Addendum Number: No. 05

Addendum issued for the following informational changes and updates.

Clarksburg State Office Building
Addendum Bulletin No.005

Clarksburg State Office Building
GSD 136433

E101

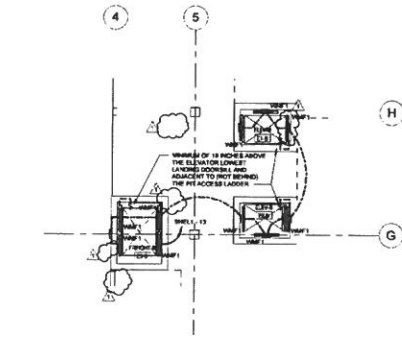
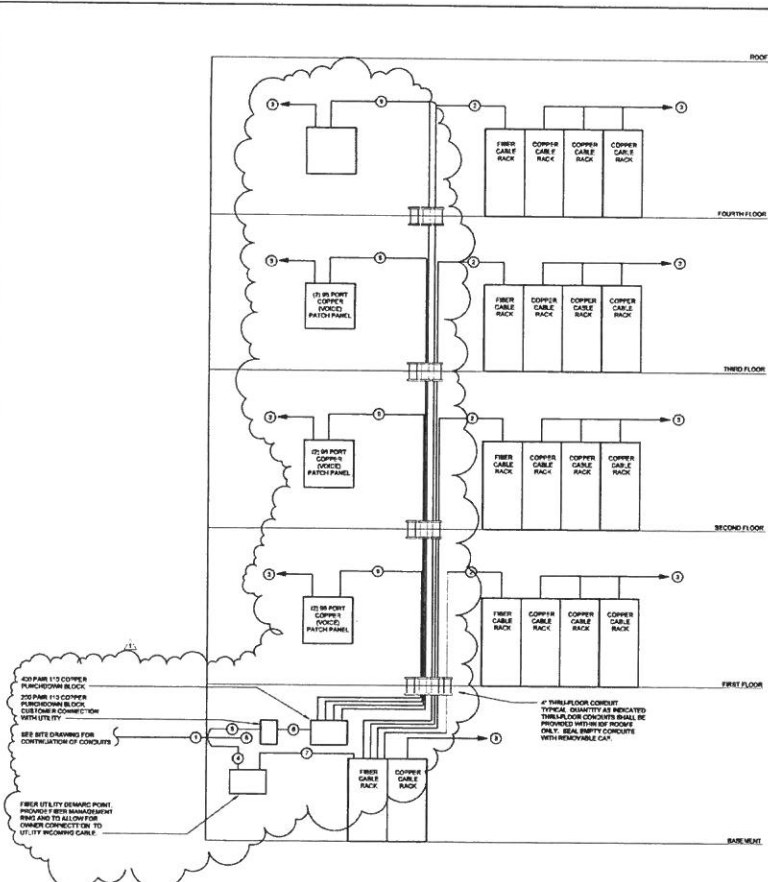
- 1.) Bid Opening Changed from: 03/13/2014 at 1:30 PM. EST.
to: 03/20/2014 at 1:30 PM. EST.
- 2.) Alpha Information
- 3.) Drawings E101 & E403
- 4.) No other Changes.

1 COORDINATE FINAL LOCATION OF TYPE 'M' FIXTURES IN PLAN TOP DRAWING WITH ELEVATOR INSTALLER.
